**APP/M1900/W/21/3278097**  
**WITNESS STATEMENT**

**Bromate contamination significant to  
The proposed quarrying activity at the Hatfield Aerodrome**

By:	Michael Hartung - Member of Ellenbrook Area Residents Association
Date:	17 October, 2021
Use:	Appeal <b>APP/M1900/W/21/3278097</b> (Nov. 2021) on rejection of proposed quarrying activity, Hatfield Aerodrome
Witness called by:	Ellenbrook Area Residents Association (EARA) and Smallford Residents Associations (SRA)

2.15 On a map provided by SLR, February 2019, LMA bromate concentrations, DWG No2, April 2019, localised plume contours show the modelled southern plume boundary in relation to the quarry site.

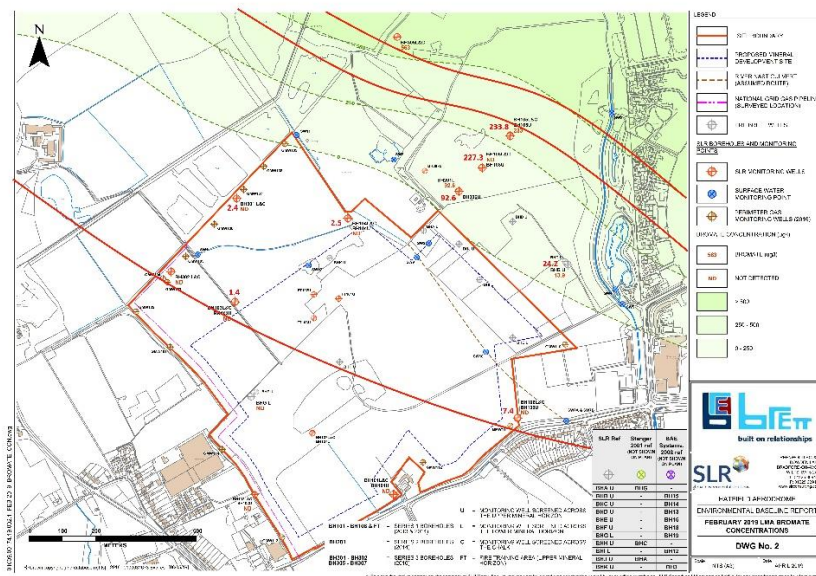
This map shows the plume skirting the quarry site and infers that there is no bromate beneath the proposed working area.

However, the borehole data taken in 2019 provided by SLR as shown in Appendix 1 and the Table 1 extract above clearly shows that bromate was present at boreholes surrounding the dig site. The quarterly figures for bromate in chalk and LMH are over 0.5µg/l which according to the inspector are within the plume boundaries.

The information on the SLR map does not correlate with the information on the dataset also provided by SLR for example borehole 104 at the very edge of the dig site shows readings for each date in 2019, but the map says none detected. Similarly for boreholes 301 and 103.

## 2.18 A conceptual idea of the plume

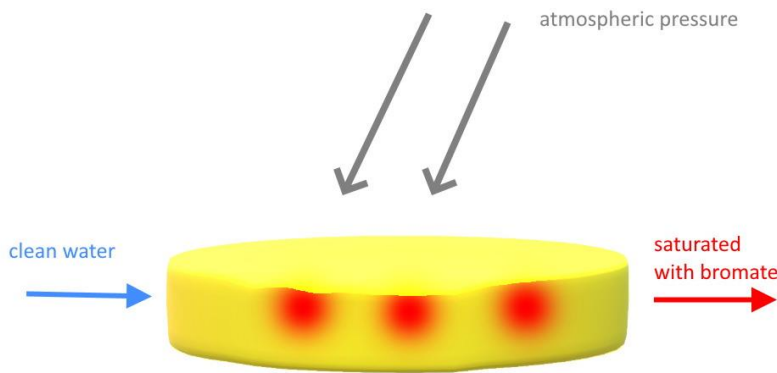
2.20 The idea that the plume is moving and yet static can be easily understood by analogy of a sponge that is impregnated with salt and drip fed with clean water. The sponge would leach salty water and taste of salt for a long time. The rate of the flow is set by the drip frequency. The plume flows from West to East saturated with bromate, the gravel in the LMH aquifer acts as storage or sponge – in this case static – and not moving.

This picture demonstrates how the plume flow is operating.
